# MESA FALCON FIELD AIRPORT (FFZ) MIDFIELD CROSSOVER TAXIWAY EAST AND REALIGNMENT OF TAXIWAYS D7 AND D8

# PROJECT NO. <u>CP0994EAST</u> FAA AIP No. 03-04-0023-035-2023

# ADDENDUM NO. 1 05/08/2023

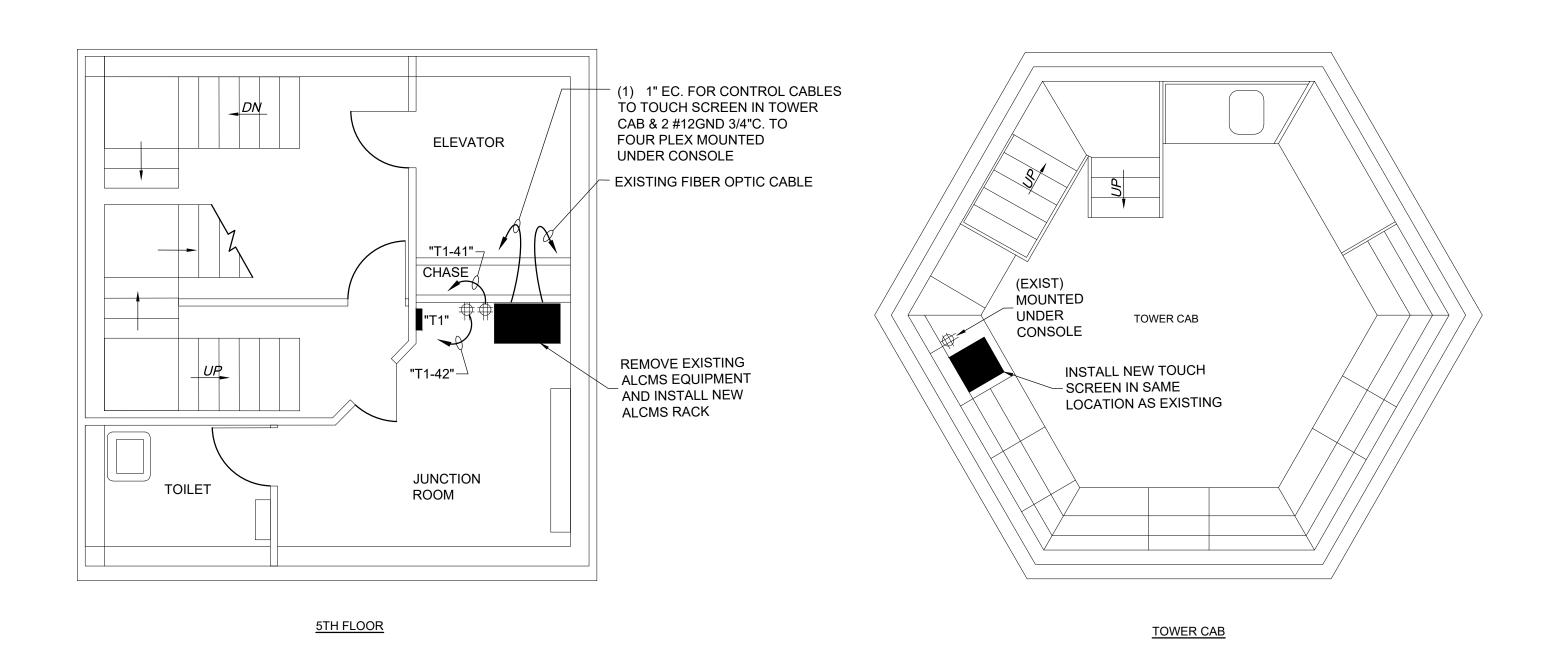
Sheet 52 of 52 (A-270571), Drawing E253 - ELECTRICAL DETAILS. Note 3 shall read "CONTRACTOR SHALL INSTALL L-827 MONITORING BOXES FOR EACH CCR. MONITORING SHALL INCLUDE IRMS AND OUTPUT MONITORING. COMBO BOXES SHALL ALSO BE INSTALLED FOR EACH NAVAID THAT WILL BE CONTORLLED BY THE ALCMS."

Further definition of the required equipment for the ALCMS was given.
